PROJECT TITLE Ponca Warehouse

TITLE: PONCA WAREHOUSE DRAINAGE PLAN

Re: Ponca Warehouse Drainage Plan

An initial review of the referenced report has resulted in the comments listed below. The numbers indicated refer to the Drainage Report (DR) or Construction Plan (CP) Checklists. Please supply the following information:

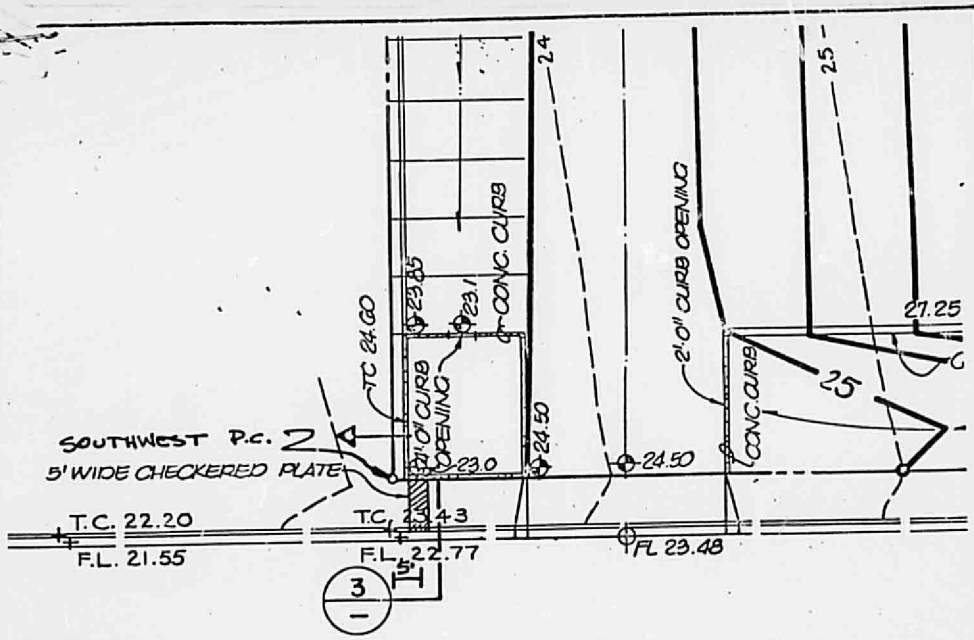
D. DR #6 - Please address the fact that ponding does not occur within 15 feet of any structure.

E. DR #15-B1 - The pond volume calculations shown for the west side pond are difficult to follow. Please clarify these calculations; showing cross sections may help.

F. DR #15-B3 - Are there any emergency spillways for either pond? Please show calculation for these spillways and indicate their locations and depth of flow.

G. DR #18-B & CP #3 - Please include legal description on the grading plan.

H. DR #19-A & CP #4 - Please reference Albuquerque Control Survey Vertical Datum Location.

D. Ponding does not occur within fifteen (15) feet of the structure. All ponding occurs on asphalt surfaces, therefore, it really would not make any difference if it was adjacent to a building since the ponds all have positive outlets.

E. The volume for the west pond was calculated essentially using the end area method. The first series of numbers, 24 x 200 x 0.5, represents an area 24 feet wide, which is the width from the property line to the 24 contour. It is 200 feet long, the depth varies from 0-1 foot; therefore, I used an average depth of 0.5 foot.

The next area represents the area just to the north of that, which is actually 24 x 100 feet; however, it is on a slope so I used half of the width rather than the full slope, and it has a depth varying from 0.5 feet, so again, I used an verage depth of 0.25 foot.

The third group of numbers is the area that lies essentially over the 24 contour, extending from the 24.5 contour to the west property line. It is an area 36 feet wide, 200 feet long and there is depth of water over that whole area of 0.5 feet. When all that is multiplied out, you have 6,400 cubic feet.

F. There is an emergency spillway to both ponds. The pond to the east has an emergency spillway along the north side of the building at approximately the west corner. Sections 1 and 2 describe the construction of that berm/outlet/spillway. The spillway has a capacity of approximately 10.6 cfs at a 6-inch depth. That depth would be below the curb height adjacent to it. That flow is also less than the 100-year flow out at the east area.

The second area that we chose as a spillway was the driveway at the southeast corner of the site. If the pond were to overflow, it would flow through the driveway into the street. The spillway area would have a capacity of approximately 10.7 cfs at 0.2 foot depth. That flow would approximately be equivalent to the 100-year storm from the entire site.

G. A legal description has been added to the drawing.

H. Below the Legend we have described the Albuquerque Control Datum as being Monument 9-D-17.

DRAINAGE PLAN

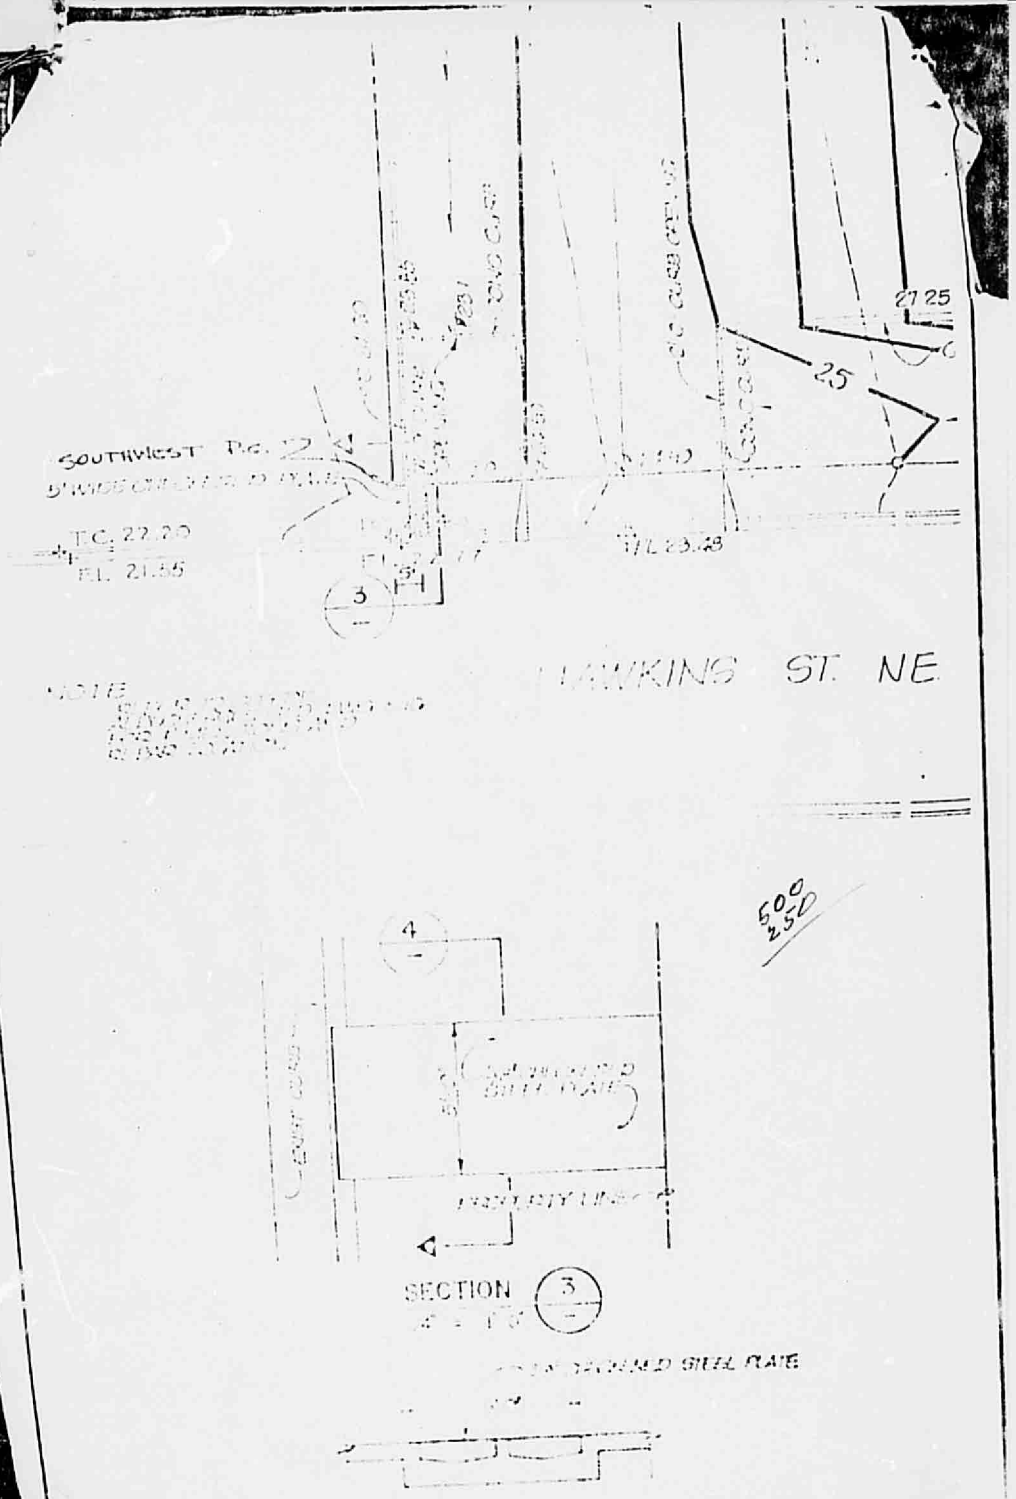
Was not called to job site till Drain was already Built met with Emil & Contractor was Draining ok Emil said it would be ok to accept steel Plate Placed but not tied down with flat head screws
